Access Compliance Report

Public Rights-of-Way

Intersection ID: 31445	Main Street: RIDING_HILL_AV	Cross Street: UNDERWOOD_AV	Location: S
ADA ID: B6BF3C8319EA	Ramp Type: PerpDiag	Initial Pass/Fail: Fail	Overall Compliance: No
			Severity Score: 13.75

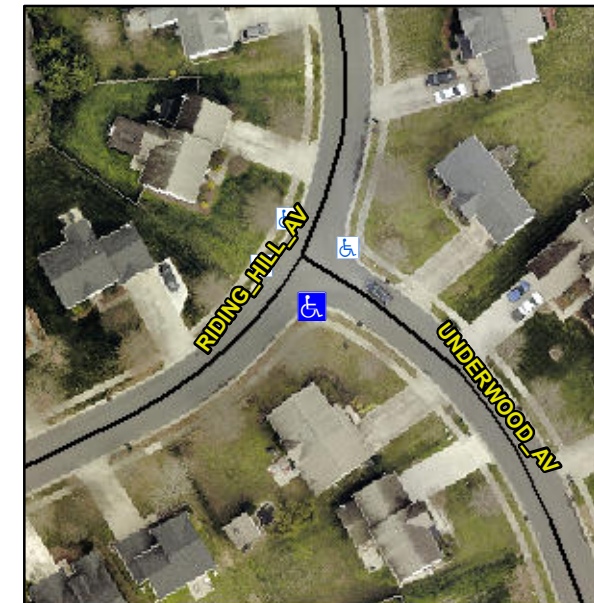
Not Found, R304.2.2, R304.5.3

Compliance	Description	Data	Compliance	Description	Data
N/A	Ramp Length (in)	63.0	No	Ramp Slope (%)	8.7
Yes	Ramp Width (in)	48.0	No	Ramp XSlope (%)	3.7
N/A	Flare Type LT	N/A	N/A	Flare Type RT	N/A
N/A	Flare Slope LT (%)	N/A	N/A	Flare Slope RT (%)	N/A
N/A	Flare Traversable LT?	N/A	N/A	Flare Traversable RT?	N/A
N/A	Landing Length (in)	N/A	N/A	DWS Provided?	N/A
N/A	Landing Width (in)	N/A	N/A	DWS Contrast?	N/A
N/A	Landing Slope (%)	N/A	N/A	DWS Length (in)	N/A
N/A	Landing X Slope (%)	N/A	N/A	DWS Full Width?	N/A
N/A	Landing Curb? (Y/N)	N/A	N/A	DWS Offset (in)	N/A
N/A	Shared Landing?	N/A			
N/A	Gutter Ponding?	N/A	N/A	Gutter Slope (%)	N/A
N/A	Gutter Lip Ht (in)	N/A	N/A	Gutter X Slope (%)	N/A
N/A	Painted X Walk1?	No	N/A	Painted X Walk2?	No
	X Walk 1 Direction	To NE		X Walk 2 Direction	To NW
N/A	X Walk 1 Width (in)	N/A	N/A	X Walk 2 Width (in)	N/A
	X Walk 1 Slope (%)	1.8		X Walk 2 Slope (%)	3.4
	X Walk 1 X Slope (%)	3.4		X Walk 2 X Slope (%)	1.5

Remove & Replace Curb Ramp With Two New Directional Ramps or Equivalent.
